TO: Dr. Jesse Bacon, Superintendent
FROM: Danny Clemens, Director of Facilities
Date: February 9, 2024
RE: Bernheim Middle School - Change Order 7 - Concrete Pad Removal Art Closet **DC**

Change Order

PROJECT: *(Name and address)*
Bernheim Middle School Renovation
700 Audubon Drive, Shepherdsville, KY
40165

Change Order Request 11 - PCO #36 - RFP-9 Removal of Concrete Pad at Storage 120D

1 ENLARGED PLAN- ART CLASSROOM DEMO - RFP- 9
3/32" = 1'-0"

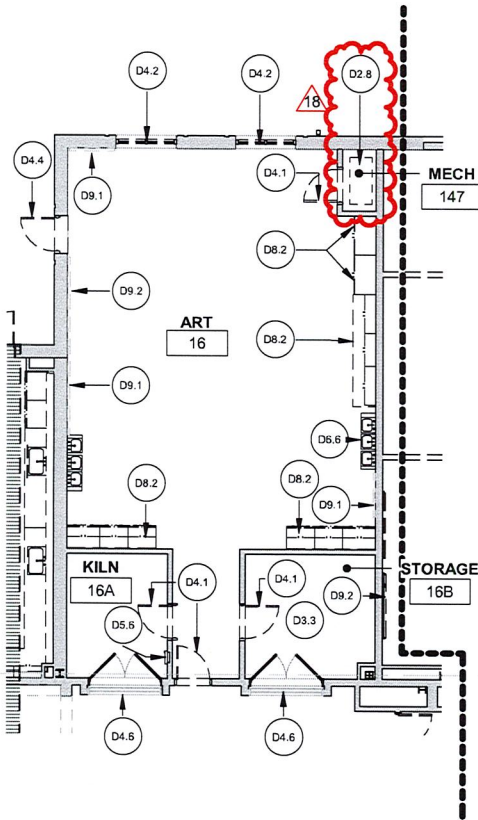
- Remove concrete slab in Art Room Closet. Patch and repair slab as needed for a smooth finish.

18. D2.8	REMOVE CONCRETE PAD, COMPLETE. REPAIR OR PATCH SLAB AS REQUIRED FOR A SMOOTH FINISH.
D3.3	REMOVE AND DISPOSE OF GYP. BOARD CEILING ASSEMBLY, COMPLETE.
D4.1	REMOVE AND DISPOSE OF EXISTING DOOR AND HARDWARE. DOOR FRAME TO REMAIN, PREP FOR NEW DOOR INSTALLATION. IF HOLD OPENS ARE REMOVED, REPAIR VOIDS IN WALLS TO MATCH ADJACENT CONSTRUCTION.
D4.2	REMOVE AND DISPOSE OF EXISTING WINDOW ASSEMBLY, COMPLETE. PREPARE OPENING FOR NEW WINDOW INSTALLATION.
D4.4	REMOVE AND DISPOSE OF EXISTING DOOR, HARDWARE, AND FRAME, COMPLETE.
D4.6	EXISTING WINDOW ASSEMBLY TO REMAIN. PROTECT DURING CONSTRUCTION.
D5.6	REMOVE AND DISPOSE OF EXISTING FIRE EXTINGUISHER CABINET. SALVAGE FIRE EXTINGUISHER AND RETURN TO SCHOOL STAFF. MAINTAIN WALL RECESS AND PREP FOR INSTALLATION OF NEW CABINET.
D6.6	EXISTING PLUMBING FIXTURE TO REMAIN. PROTECT DURING CONSTRUCTION.
D8.2	REMOVE AND DISPOSE OF EXISTING CASEWORK, COMPLETE. COORDINATE CAPPING OF ANY UTILITIES WITH MEP DRAWINGS. PATCH AND PAINT WALL TO MATCH ADJACENT CONSTRUCTION.
